Product Change Notification

End of Life Notification

Product Category : Sensors & Transducers – Electromagnetic Transducers

Issue Date : 30 - APRIL - 2020

DG85*M series

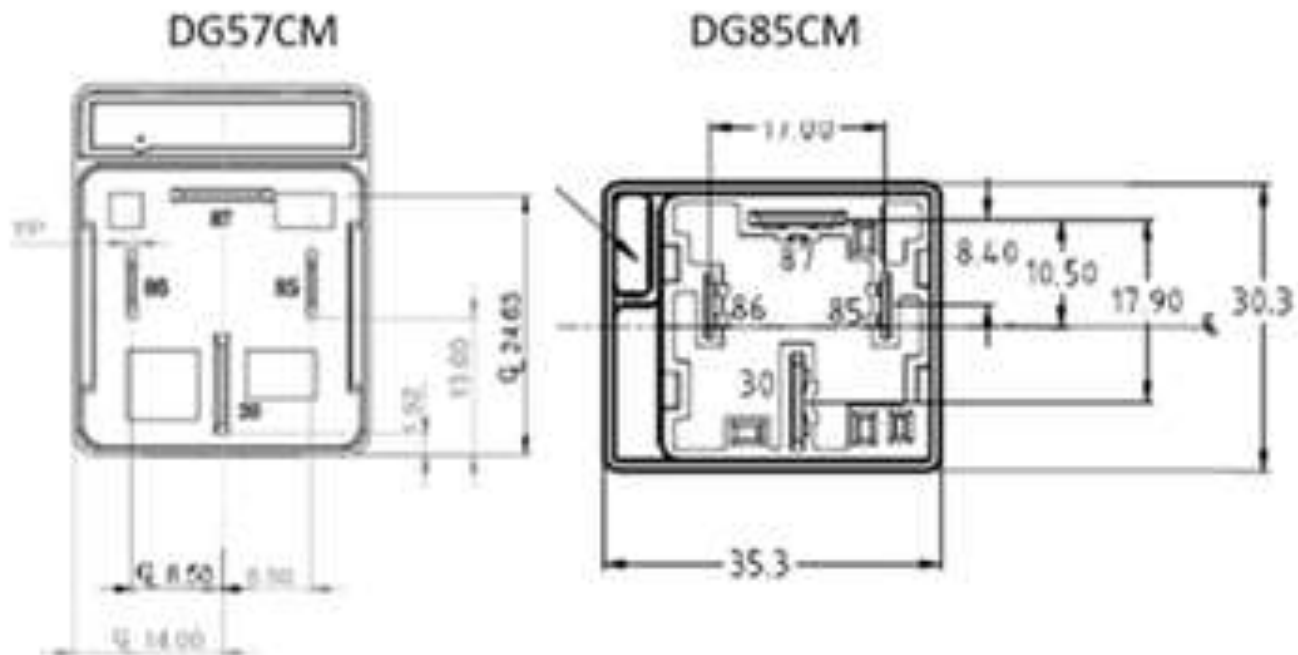
Reason For Change : We will be obsoleting the DG85BM and DG85CM series of relays and replacing with the following DG57BM and DG57CM relays

FORM/FIT/FUNCTION : The DG57BM style relay offers more robust performance and is a form, fit and function replacement to the DG85BM style relay. The DG57CM style relay offers more robust performance but is not a form, fit and function replacement to the DG85CM style relay. This is because the DG85CM has all terminals 90 degrees rotated, against the DG57CM.

END OF LIFE PART NUMBER	RECOMMENDED REPLACEMENT PART NUMBER
DG85CM-5021-76-1012	DG57CM-5021-76-1012
DG85BM-5011-76-1012	DG57BM-5021-76-1012
DG85BM-5011-76-1024	DG57BM-5011-76-1024
DG85CM-5021-76-1024	DG57CM-5011-76-1024
